#### Re: Item TE34.8: University of Toronto St. George Campus Secondary Plan - Official Plan Amendment Application - Final Report

#### Re: Draft University of Toronto Secondary Plan & Urban Design Guidelines 74 Wellesley Street East

On behalf of our client, we are writing with respect to the draft of the updated University of Toronto St. George Campus Secondary Plan (the "Secondary Plan") and draft University of Toronto St. George Campus Urban Design Guidelines (the "Guidelines"). We have reviewed the most recent versions of these two documents, dated June 13, 2022.

Figure 2.13

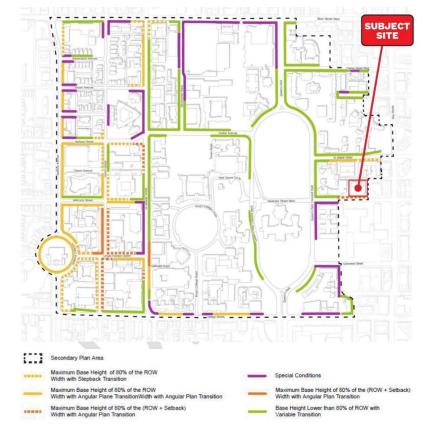
With respect to the angular plane, we note that it is unclear in Figure 2.13 of the Guidelines what the angular plane would be for the subject site. While the subject site is identified in the legend as angular plane #2, the line pattern aligns with angular plane #4, and similarly *"Maximum Base Height of 80% of Right-of-Way + Setback Width with Stepback Transition"* is not identified on Figure 2.13 in the legend, while *"Maximum Base Height of 80% of Right-of-Way + Setback Width with Stepback Transition"* is not identified on Figure 2.13 in the legend, while *"Maximum Base Height of 80% of Right-of-Way + Setback Width with Angular Plane Transition"* is identified twice. We anticipate that this is an error and would request that the guidelines be amended to address it.

Assuming angular plane #4 is intended to apply to the subject site, it is our opinion that it should be measured from the scale of the adjacent open space, not just the right-of-way. Given that the south side of Wellesley Street East is occupied by the McDonald Block office complex, with

4. Maximum Base Height of 80% of <del>Right-of-Way + Setback Width</del> adjacent public realm with Stepback Transition A pedestrian-scale base building no taller than 80% of the existing width of the <del>right-ofway plus the front setback dimension</del> adjacent public realm, including any applicable building setbacks on both sides of the street and the right-of-way width, with a minimum 3 metre stepback transition to the mid-scale institutional storeys (see Figure 2.15).

#### • <u>2.4.2.4 Taller Institutional Elements</u>

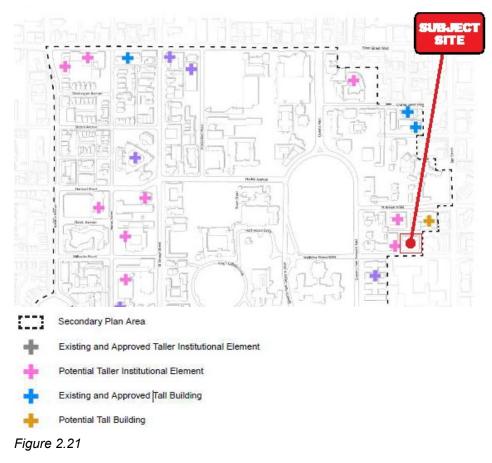
Section 2.4.2.4 provides guidance on the location of Taller Elements, providing that certain sites and blocks can accommodate additional height and density in the form of taller elements, with the taller institutional element building component generally begins above a height of 48 metres or approximately 13 storeys. Figure 2.21 shows a 'Potential Taller Institutional Element' on the sites directly west and northwest of the subject site and a 'Potential Tall Building' on the site to the northeast.

Given the size and configuration of the subject site, the subject site should be identified as 'Potential Tall Building', to provide appropriate flexibility for redevelopment of the subject site. Given that the guidelines provide that more detail regarding taller elements will be provided on a block specific basis, confirmation of and specific matters such as the location of the taller element, maximum floorplate size, separation distances and setbacks can be determined at subsequent stages of the process through a planning application for the subject site.
